NOTICE OF ADDENDUM
ADDENDUM NO. 4
CONTRACT NO. 8716

EAST-WEST BUS RAPID TRANSIT IMPROVEMENT

Addendum 4: Requests for Information

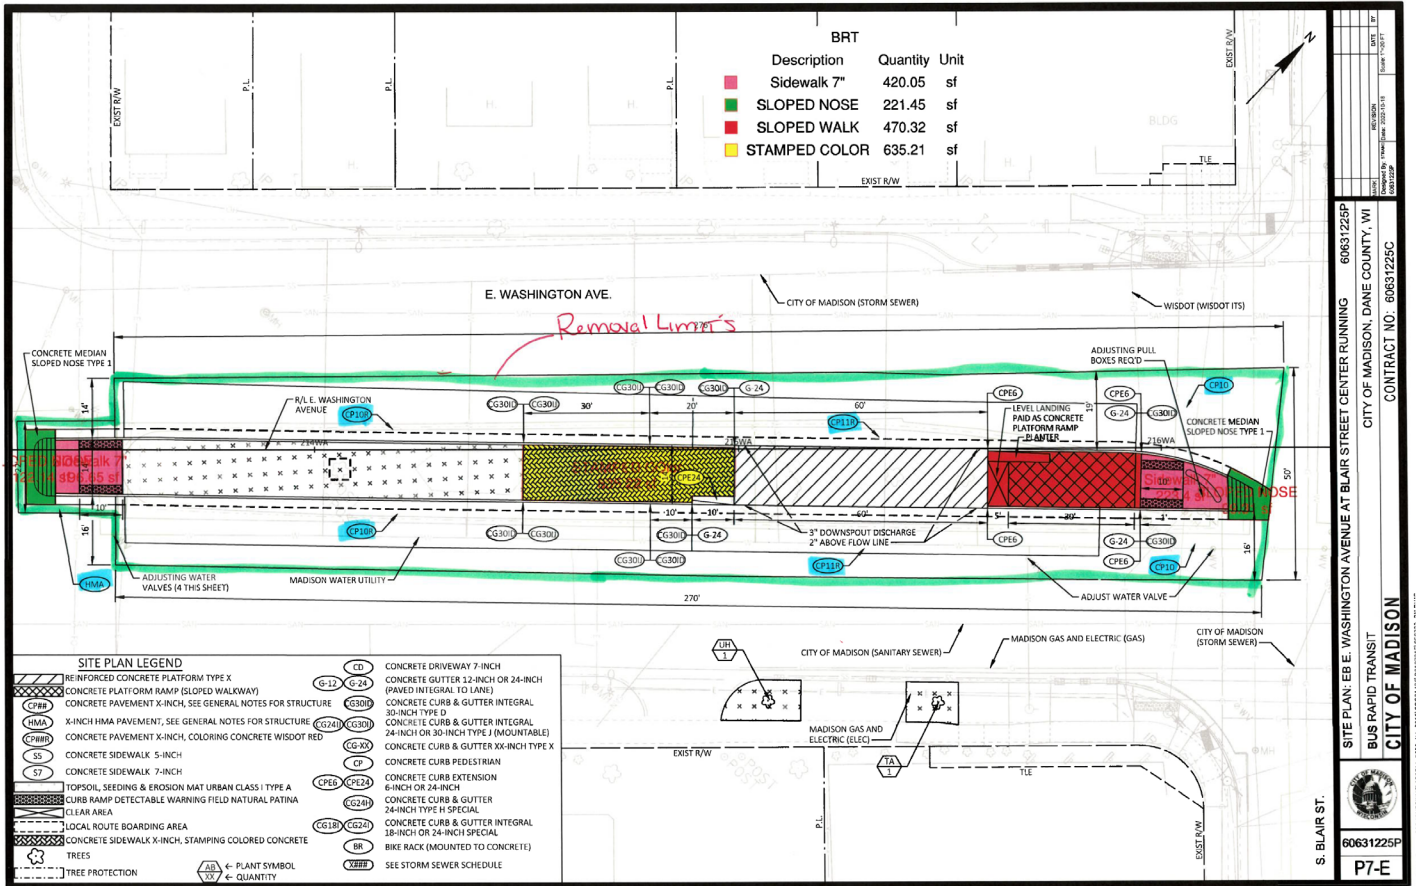
For five questions below, refer to this drawing:

Q: Can you confirm that the green line is removal limits?

Q: Between removal limits and curbs, where are the dividing lines between HMA patch, CPR10, CPR11 and CP10?

Q: Is the area in red all paid as Concrete Platform Ramp (Sloped Walkway)?

Q: Is the area in Pink all paid as sidewalk 7"?

Q: Is the green all Sloped Nose?

A: Yes. Intent is to remove to the nearest joint line. The green line represents the removal limits corresponding to the as-surveyed joint lines before the current construction project ongoing at Blair Street.

A: HMA is at the west end where there is existing asphalt (west of points BSC79 & BSC80 shown on the Grading Plan G7-E). Purpose is to set the forms for the new curb as the median is being extended. The red pavement is the entire "bus" lane from crosswalk to crosswalk/stop bar (nearest joint to referenced marking). This represents between BSC17 and BSC81 on the grading plans for EB; see Grading Plan G7-E for similar points used to denote WB. The 11" concrete pavement is quantified from the eastern crosswalk/stop bar to the end of the concrete platform extension in the bus lane on both sides of the station platform. All other roadway concrete pavement is 10" concrete pavement.

A: Yes.

A: Yes.

A: Yes.
